18C Operator Interface Equipment Characterization

STD DEP T1 3.4-1 (Figure 18C-8)

Figure 18C-8 Overall Configuration of Operator Interface System

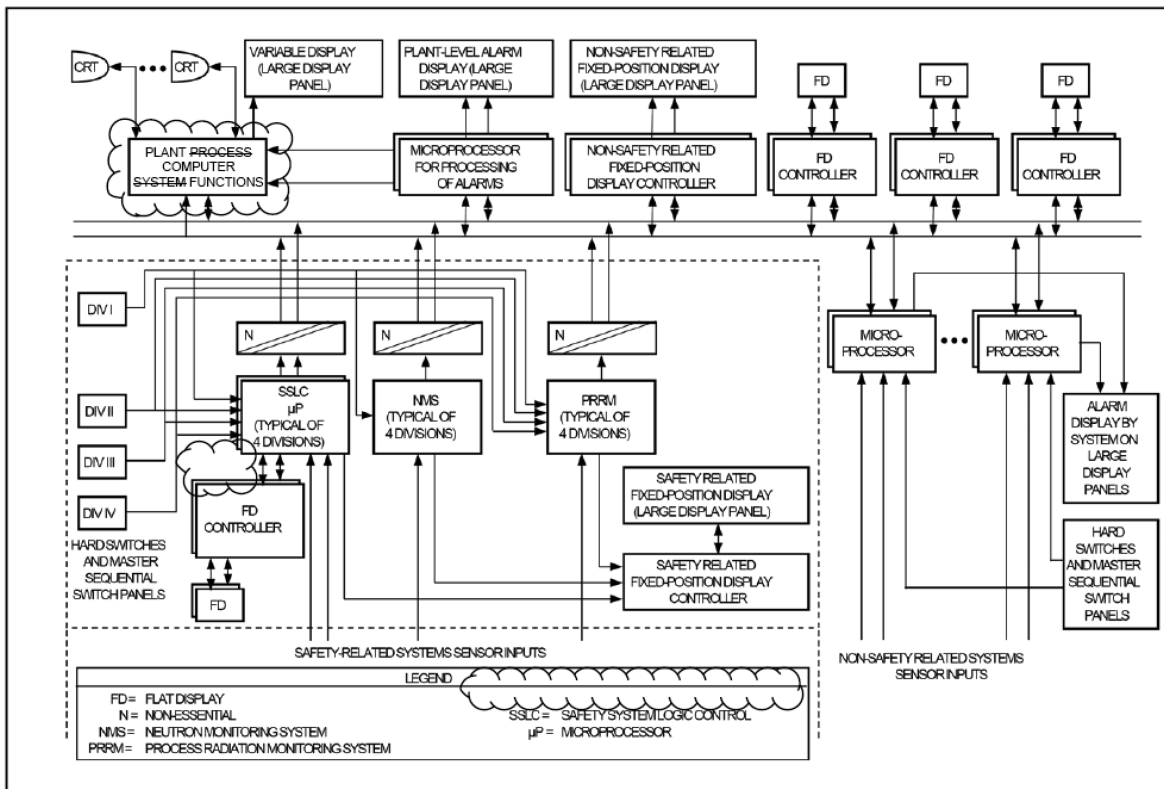
A characterization of the plant instrumentation and control systems architecture which supports the control room operator interface is illustrated in Figure 18C-8. As shown in Figure 18C-8, display and control capability for both safety-related and non-safety-related systems are driven by microprocessors which are independent of the redundant plant process computer functions. This assures the ability to safely shut down the plant in the unlikely event of computer failure. In the case of the safety-related systems, the microprocessors are divisionally dedicated and are each electrically isolated from the rest of the system.

The instrumentation and control systems architecture is not identical to the conceptual design described in Appendix 18C. The changes in the next paragraph reflect the architecture and configuration.

~~The plant wide, fiber optic Essential Multiplexing System (EMUX) provides the communications network for the system. This multiplexing system is actually a series of data acquisition and control networks, separate networks being provided for safety related and non safety related plant systems.~~ The data communication function includes both safety-related and non-safety-related communication performed by separate networks as described in Section 7.9S.
